APPLICATION FOR ZONING CHANGE

APPLICATION FOR CONDITIONAL USE PERMIT

In response to your development submission for the proposed Grand Prix and mini golf facility on south SH-205 the following items still need to be addressed:

Agenda Item: **P&Z 91-41-Z/CUP/PP** - Hold Public Hearing and Consider Recommending Approval of a Request from Mike Slavens for a Change in Zoning from "A" Agricultural to "C" Commercial, CUP for a Commercial Amusement, and a Preliminary Plat for a Tract of Land Located on SH-205 South of Mims Road

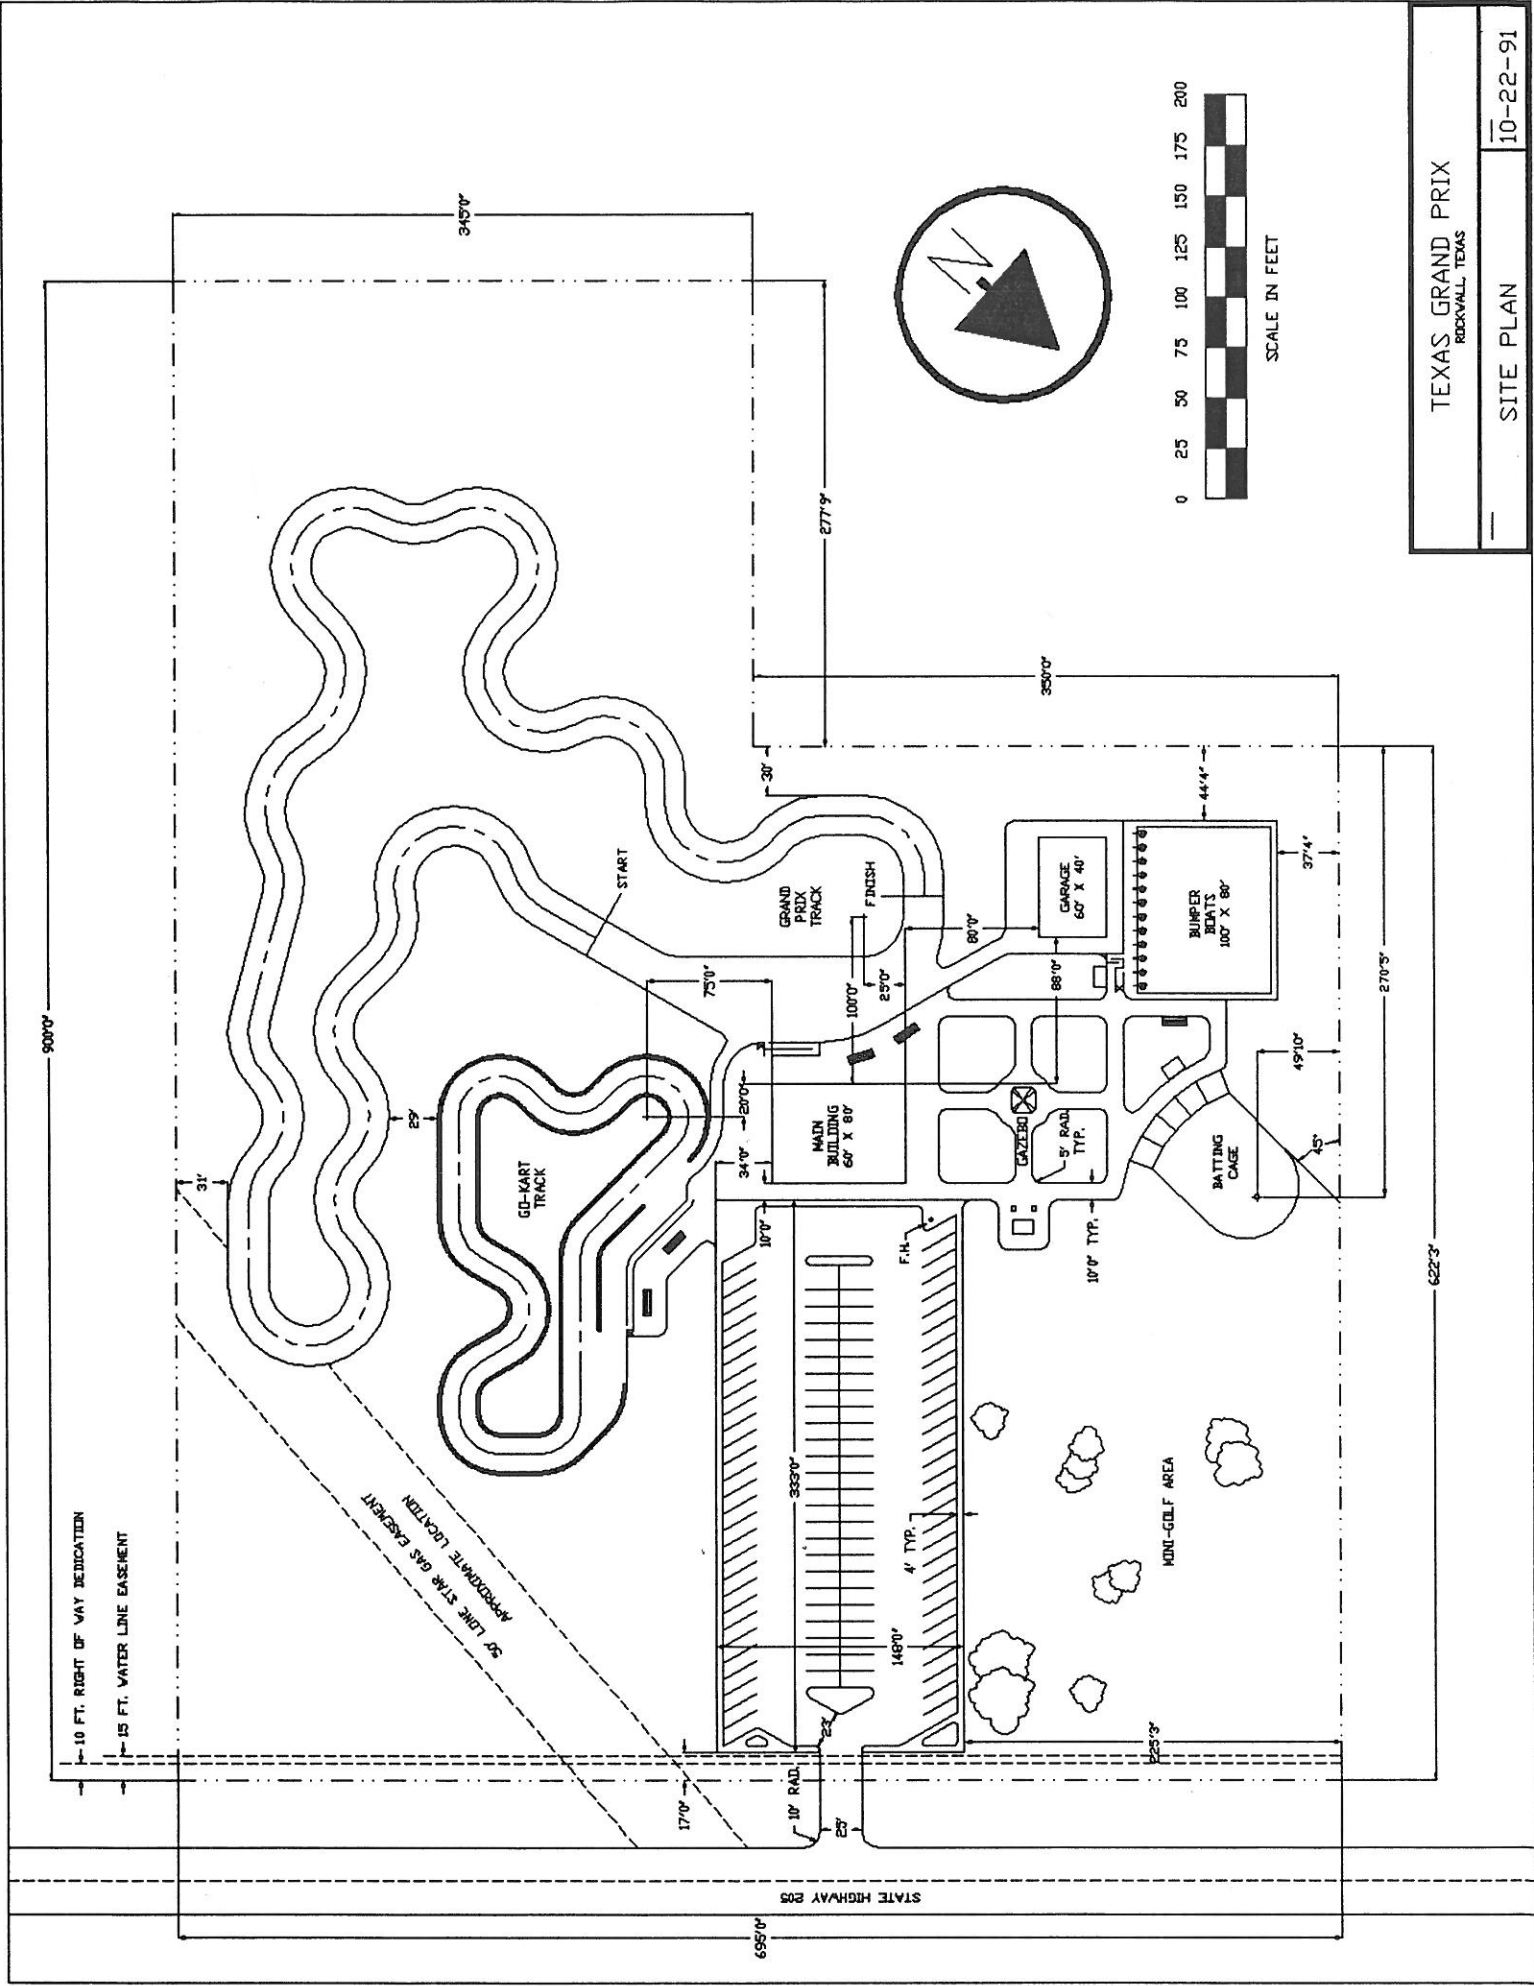
<u>Yes</u>	<u>No</u>	<u>N/A</u>
<u>Planning</u>			
1. Is the site zoned properly? <i>as per map been made</i>	_____	<u>X</u>	_____
2. Does the use conform to the Land Use Plan?	<u>✓</u>	_____	_____
3. Is this project in compliance with the provisions of a Concept Plan?	_____	_____	<u>✓</u>
✓ 4. Is the property platted? <i>pub. plat</i>	_____	<u>✓</u>	_____
✓ 5. Is plat filed of record at Courthouse? File No. _____	_____	_____	<u>✓</u>
✓ 6. If not, is this site plan serving as a preliminary plat?	<u>✓</u>	<u> </u>	_____
7. Does the plan conform to the Comprehensive Zoning Ordinance or PD Ordinance on the following:			
a. Are setbacks correct?			
front	<u>✓</u>	_____	_____
side	<u>✓</u>	_____	_____
rear	<u>✓</u>	_____	_____
b. Are buildings on same lot adequately separated?	<u>✓</u>	_____	_____

c.	Is the lot the proper size?	☒	☐	☐
d.	Does the lot have proper dimensions?	☒	☐	☐
e.	Are exterior materials correct? <i>need to know</i>	☐	☐	☐
f.	Are structural materials correct?	☒	☐	☐

g.	Is coverage correct?	☒	☐	☐
h.	Is adequate area in landscaping shown? <i>need</i>	☐	☐	☐
i.	Is it irrigated? <i>need</i>	☐	☐	☐
j.	Is landscaping in parking lot required?	☒	☐	☐

k.	Are types of landscaping indicated? <i>no</i>	☐	☐	☐
l.	Is floor area ratio correct?	☒	☐	☐
m.	Is building height correct?	☒	☐	☐
n.	Are correct number of parking spaces provided? <i>need info</i>	☐	☐	☐

o.	Are driving lanes adequate in width? <i>is wide</i>	☒	☐	☐
p.	Are parking spaces dimensioned properly	☒	☐	☐
q.	Does the parking lot meet City specifications	☐	☐	☐

r.	Is a fire lane provided? <i>need to check needs designation</i>	☒	☐	☐
s.	Is it adequate in width?	☒	☐	☐
t.	Are drive entrances properly spaced?	☒	☐	☐
u.	Are drive entrances properly dimensioned? <i>need to specify radius</i>	☒	☐	☐
	Do drive entrances line up with planned median breaks?	☐	☐	☒

v.	Is lighting provided and correctly directed? <i>need info</i>	☐	☐	☐
w.	Are sidewalks required?	☒	☐	☐
x.	Are sidewalks provided? <i>205</i>	☐	☒	☐
y.	Is a screen or buffer required?	☐	☒	☐
	Is it sized properly?	☐	☐	☐
	Is it designed properly?	☐	☐	☐
	Is it of correct materials?	☐	☐	☐

Some trees to remain need to know how they will be protected

8 SITE PLAN LOCATION.

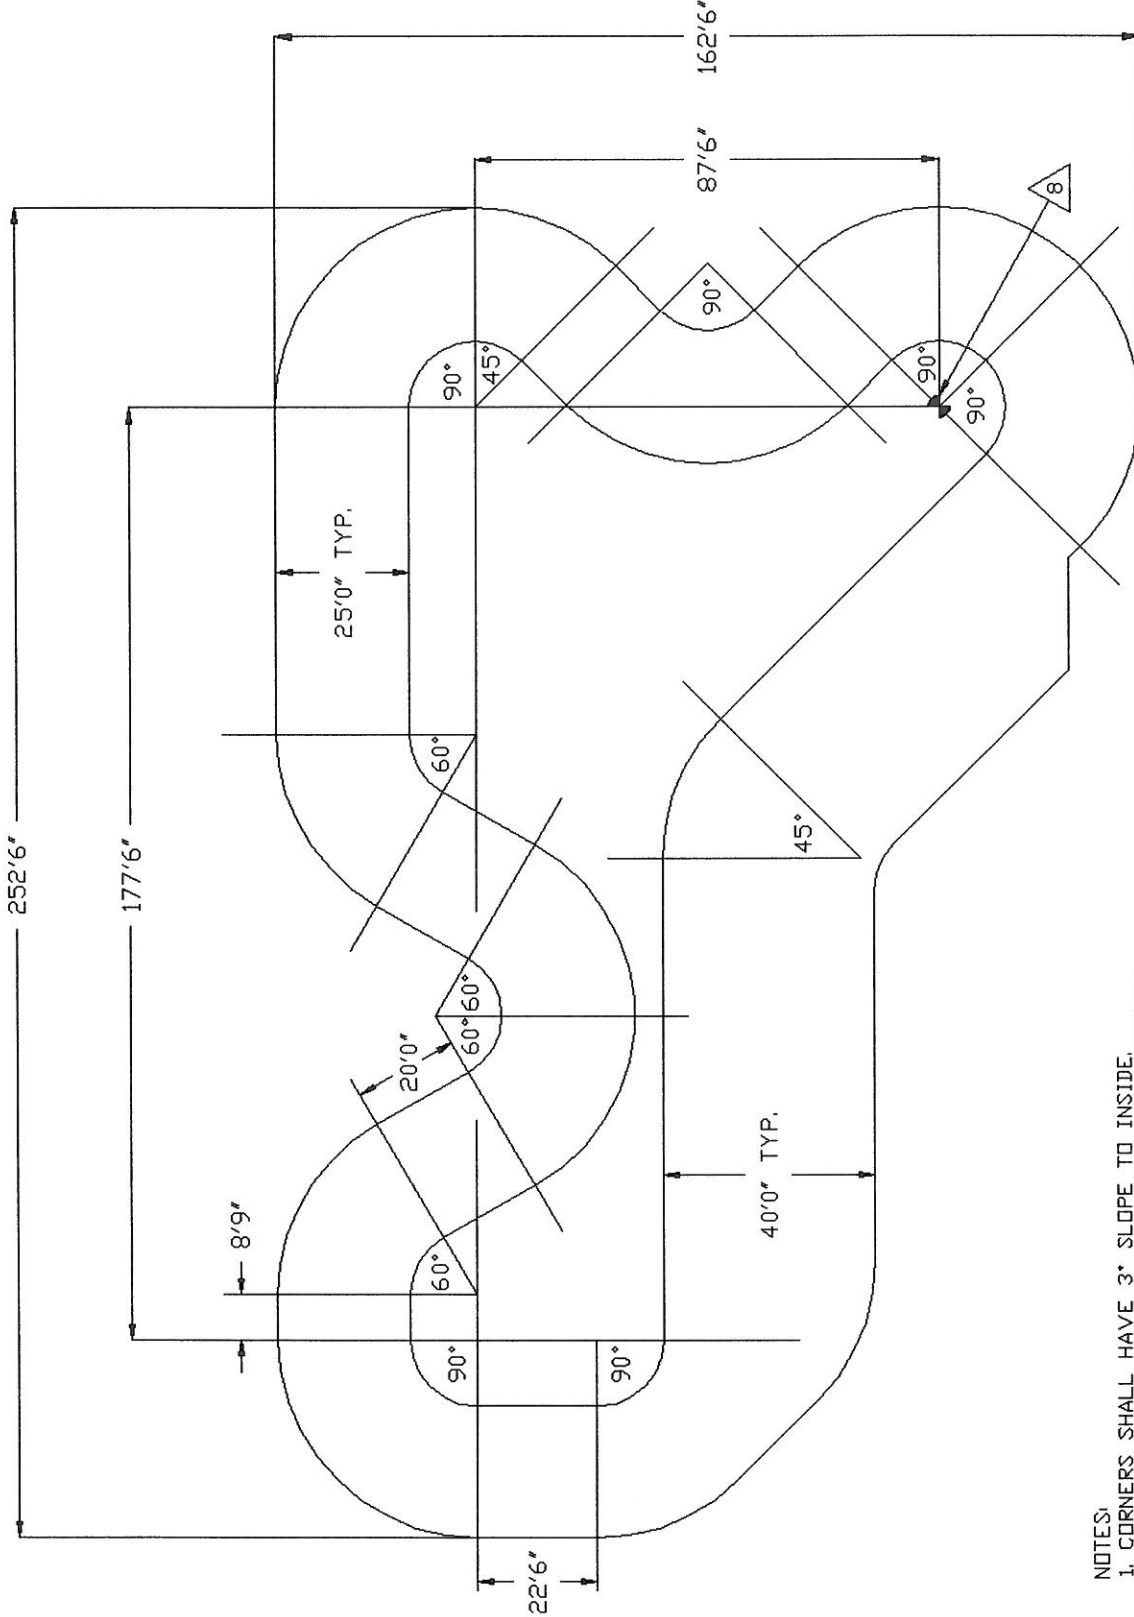
1. Sign can only be 60"
2. Parking - has 98 spaces, needs 113
needs 15 additional spaces
3. ~~Drain covers~~ 30' poles factory -
need to be checked
4. Need to show ROW dedication & easement
5. Need small blow ups at a scale that
can be measured.
6. Need more detailed landscape plan
upon design of golf course to be
submitted to staff or Commission for review
7. Building materials of all building shall be
in conformance w/ city requirements.
8. What screening around dumpster
9. All building shall meet building codes -
fireables required

1. The total site size as well as the size of the area within the City needs to be stated on the site plan.
2. Landscaping -
 - a. You need to reflect the area to be landscaped and irrigated to meet your minimum landscaping requirement.
 - b. You need to identify the required street trees on the frontage and the required trees in the parking lot. You are identifying 6 existing trees to remain that earn credits. These will reduce your street trees to 7 and the trees in the parking lot to 3. Attached is a copy of the requirements for protecting the existing trees during construction.
 - c. The trash dumpster and the screen around the dumpster needs to be identified on the site plan.
 - d. A minimum of 5% of area within the parking lot needs to be landscaped.
 - e. The parking lot and the drives need to be curbed to protect the landscaping.

- 4. Parking -
 - a. Please provide a list of the maximum capacity of each outdoor activity as well as the square footage of each building and its use for the determination of parking.

- b. The parking lot is too wide for angle parking. Additionally, if you plan to have one way drives the interior parking needs to be angled as well.
 - c. The site plan needs to identify the total number of parking spaces provided.

- d. The radius turns into the parking lot from SH-205 need to increased to 15 ft. widths.
 - e. A fire lane needs to be designated on the site plan.
- 5. Signage - please indicate the location and size of any free standing signs to be used on the site.

- 6. Buildings - please indicate the type of buildings including the exterior building materials proposed to be used.
- 7. Phasing plan - please indicate the phasing and timing of the indicated improvements.

- 8. Fuel storage - please indicate the location, amount, and type of storage facility to be used for the fuel.
- 9. Please indicate the location of the current City limits on the site plan.

- 11. Please address emergency access to the track areas. How will emergency vehicles be able to access all track areas.
- 12. As we discussed, I will need one overall revised site plan and detail sheets on the individual sections of development. I will need these revised sheets by Monday for submission to the Commission.

1. The parking lot needs to be expanded to 113 spaces based on the uses. We will review this issue in more detail prior to the meeting on Thursday.
2. The sign cannot exceed 60 sq. ft.

3. A detailed landscape plan should be submitted once the miniature golf courses are designed, for approval by either staff or Commission. The area for landscaping is adequate but the detailed plans have not been completed.

4. The buildings are going to be located within the County but not in the City. We have indicated that we would want all buildings and improvements to meet City construction codes and we would want such a condition to be included in a facilities agreement in conjunction with the final plat. The buildings are planned to be metal buildings. The applicant has indicated that they do plan to install a partial brick facade on the main building at some point in the future.

5. They are planning to use 30 ft. light poles in the parking and track areas. These need to be hooded fixtures and designed to not shine on the road or adjacent property.
